REMARKS

AMENDMENT TO THE DRAWINGS:

TRW(ASG)-6052

Annotated Sheet Showing Changes

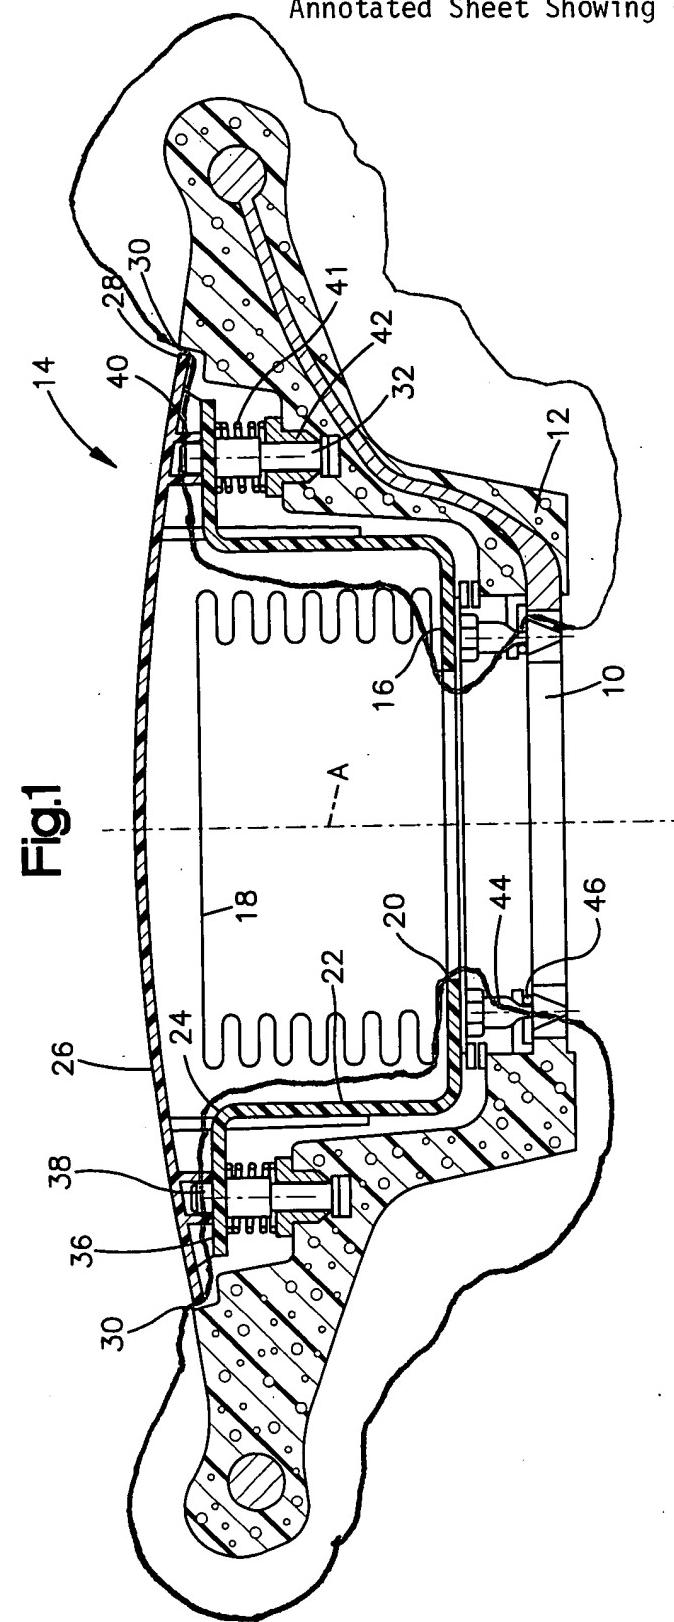
The attached sheets of drawings include changes to Figs. 1, 2, 4a, 4b, and 5. The shading for plastic for the housing (16) has been shown in Figs. 1, 2, 4a, 4b, and 5. The shading for foam for the foam casing (12) has been shown in Figs. 1 and 2. No new matter has been added. Further, reference numerals 62 and 64 have not been added to Fig. 1 because the specification does not support such an amendment.

Fig.5

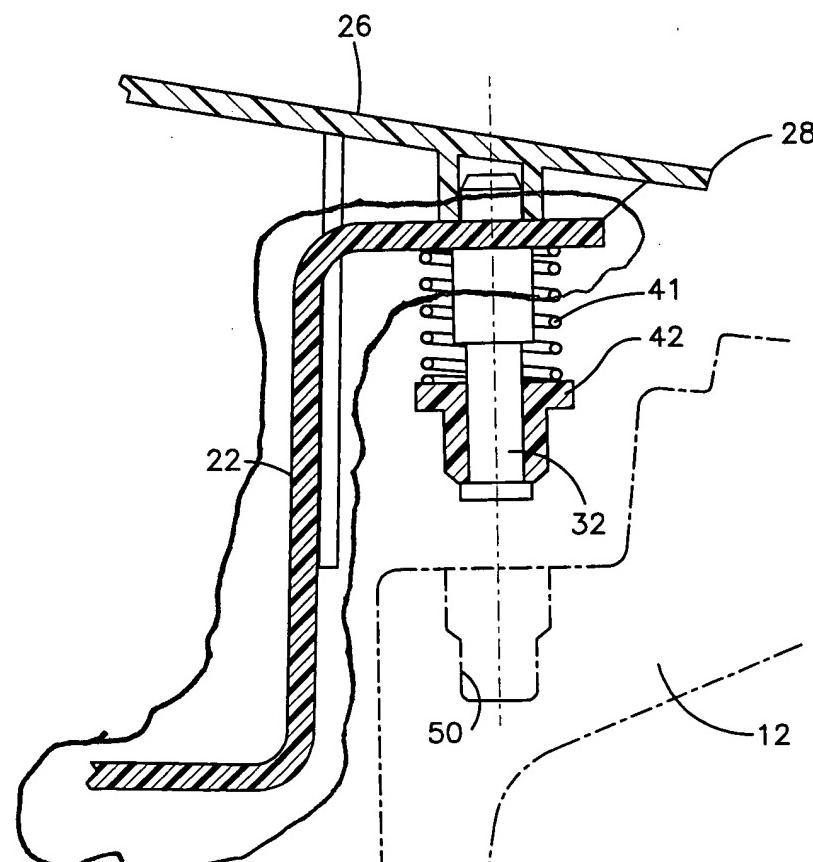
Further, the Office Action states that Bohn's flange 11 and washer 13 are similar to the flange of the instant application's bearing bushing 42. However, the flange 11 and screw 12 in Bohn secure the bolt 10 against movement. In contrast, Fig. 5 of the instant application, bushing 42 extends only a short part over the lateral dimensions of recess 50. Once again, Bohn does not disclose that the bolt may tilt.
